Retest with 1uF

Signal description

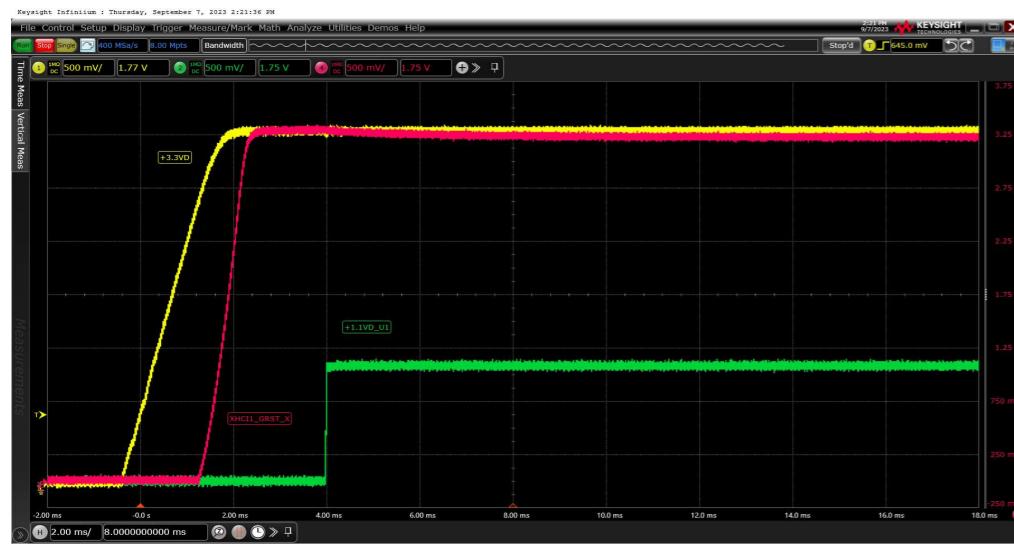
CH4 : XHCI1_GRST_X

Signal input to the GRST pin of the TUSB7320.

measuring point

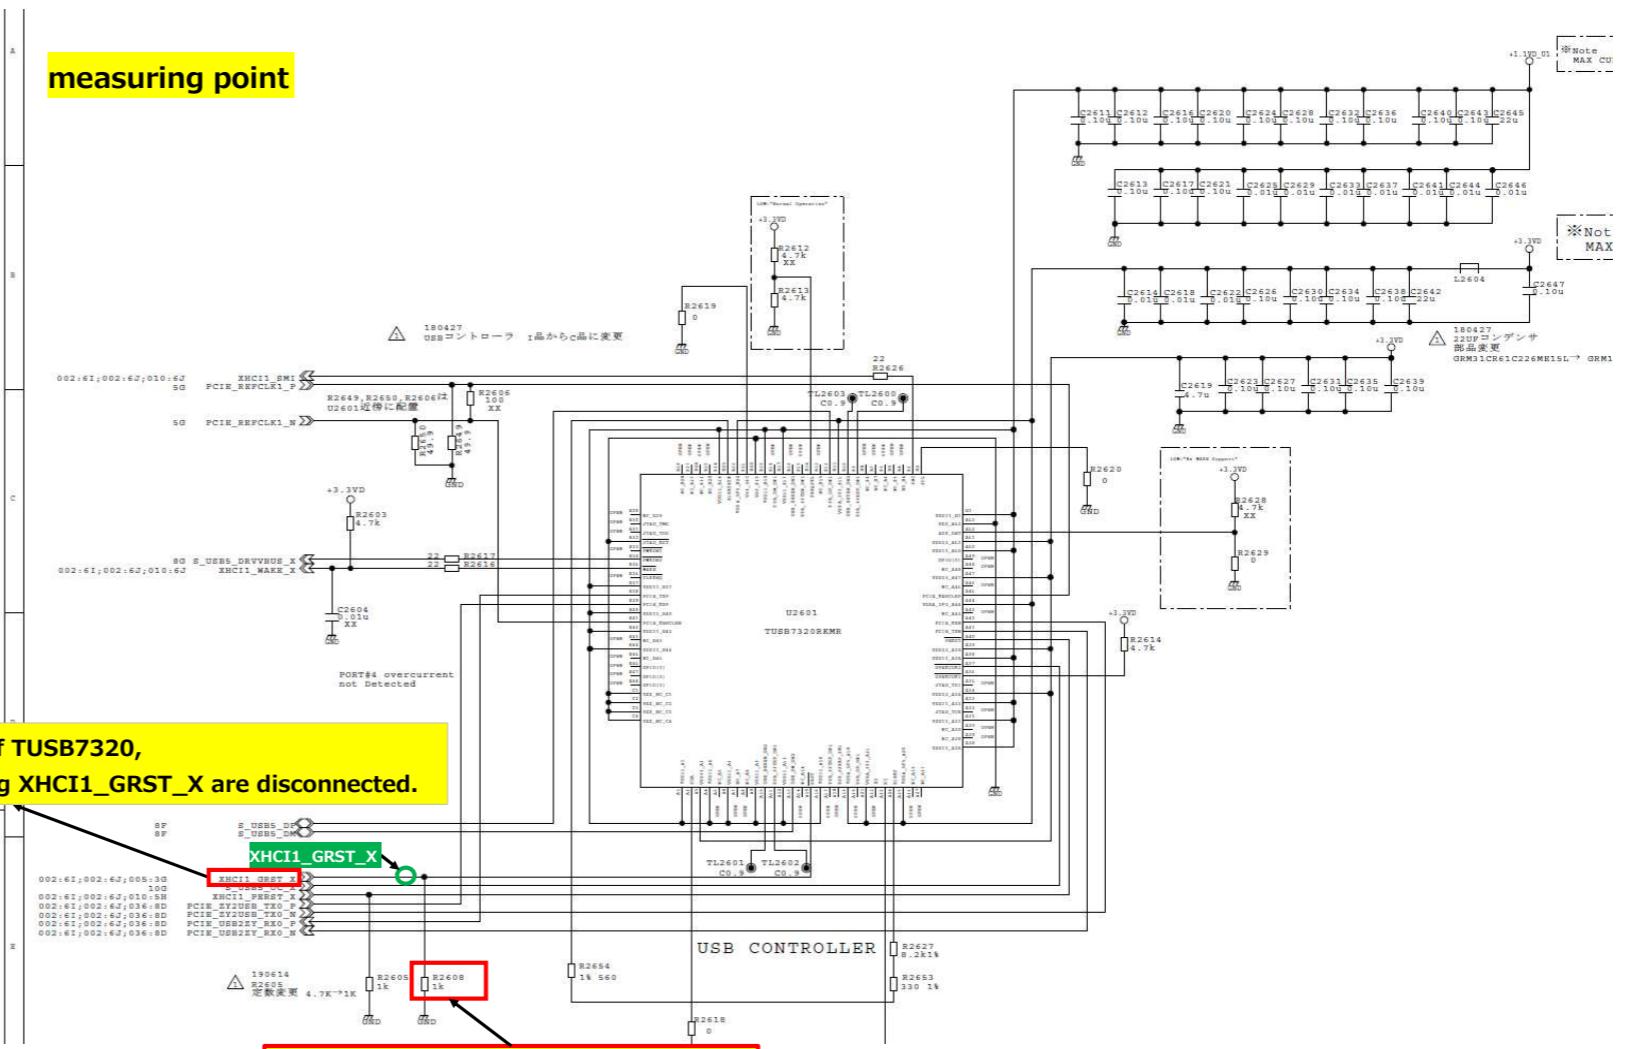
Parts change
1kΩ Pull down resistor → 1uF capacitor
